SAIB: CE-10-08

SUBJ: Wings: Zodiac CH601XL and CH650 Wing Structural Modifications **Date:** November 7, 2009

SAFETY ALERT / SAFETY DIRECTIVE

Subject/Purpose:

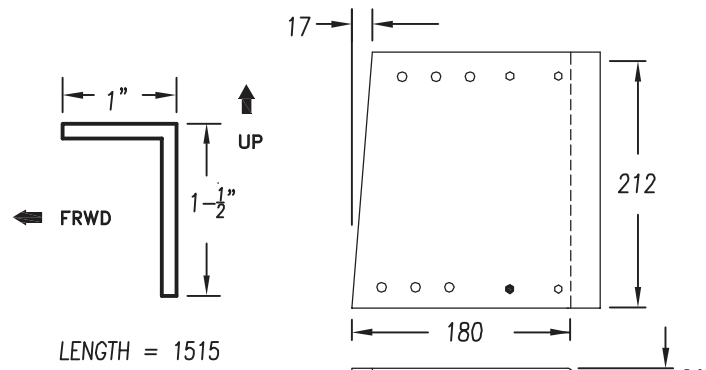
b) Inspect both ailerons for any type of deformation of the skins at the piano hinge area and root rib area. Immediately contact AMD if anything unusual is found.

| <p>ZODIAC CH 601 XL / 650</p> | <p>ZENAIR UPGRADE CENTER SPAR SECTION</p> | <p>6-ZU-2</p> |

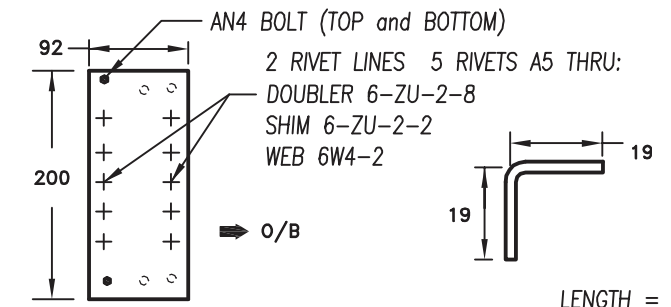
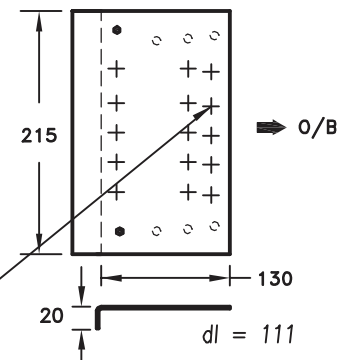
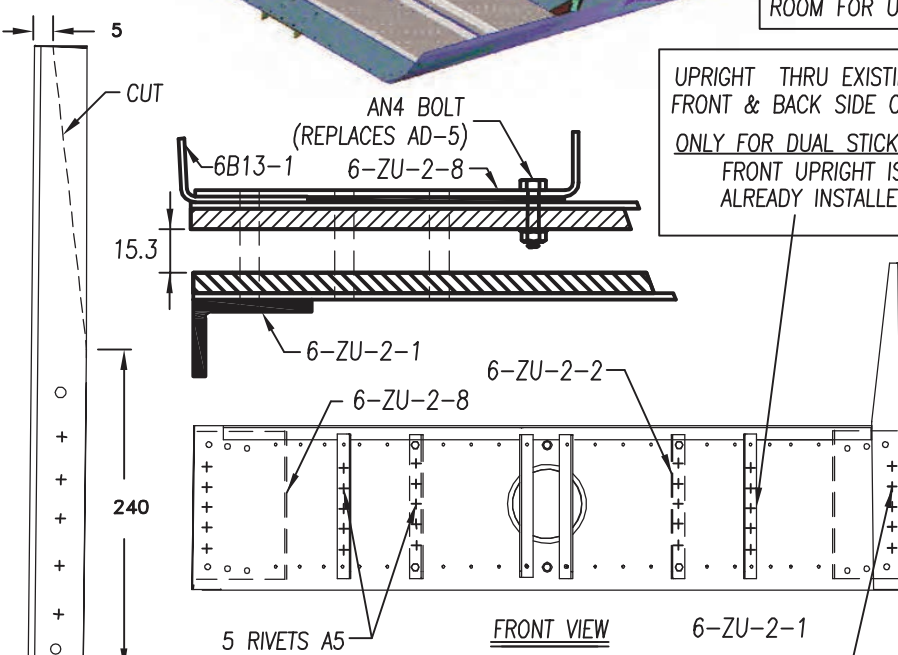
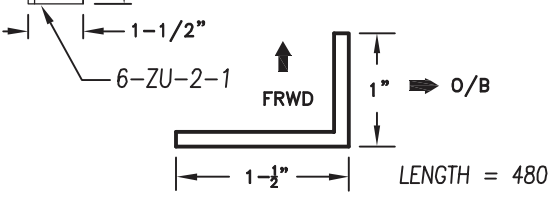
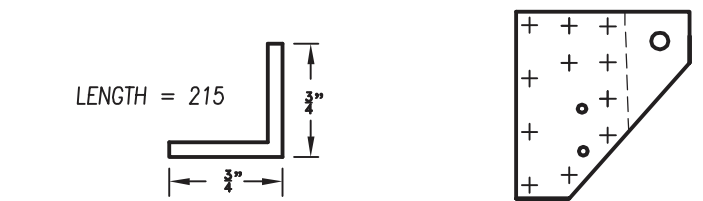
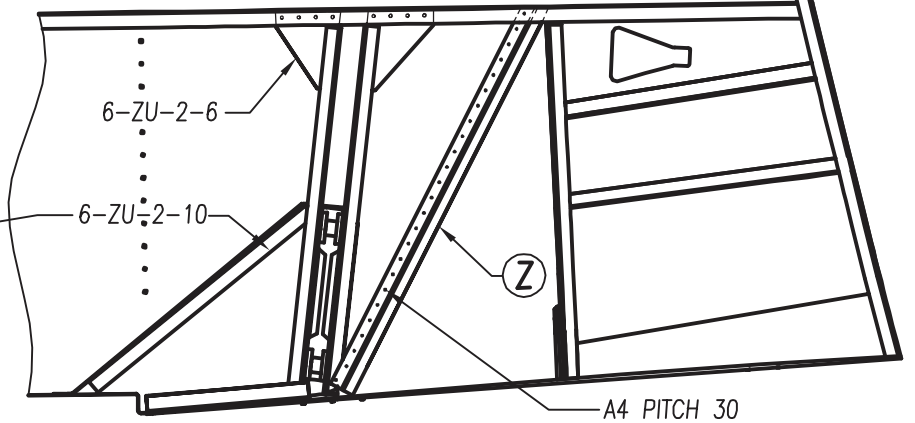
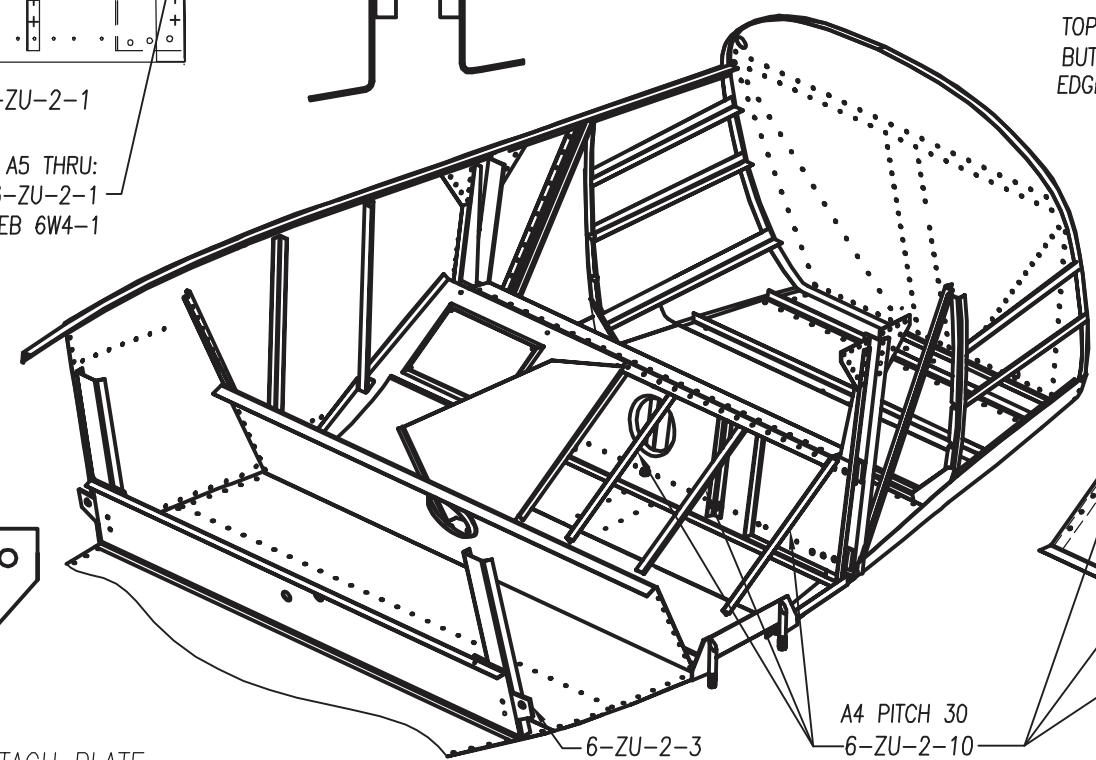
UPRIGHT THRU EXISTING BOLTS FRONT & BACK SIDE OF SPAR.
ONLY FOR DUAL STICK OPTION: FRONT UPRIGHT IS ALREADY INSTALLED.

1 FRONT WING UPRIGHTS
EXT. 6061-T6 1"x1-1/2"x1/8"
(1L + 1R REQ'D)
REPLACES 6B13-1 FRONT UPRIGHT and 65-B-13-1

5 RIVETS A5 THRU:
UPRIGHT 6-ZU-2-1
FRONT SPAR WEB 6W4-1

3 ATTACH PLATE
t=.125" 6061-T6 (1 REQ'D)
REPLACES 6B5-4 (NO CHANCES TO 65-B-5-4)
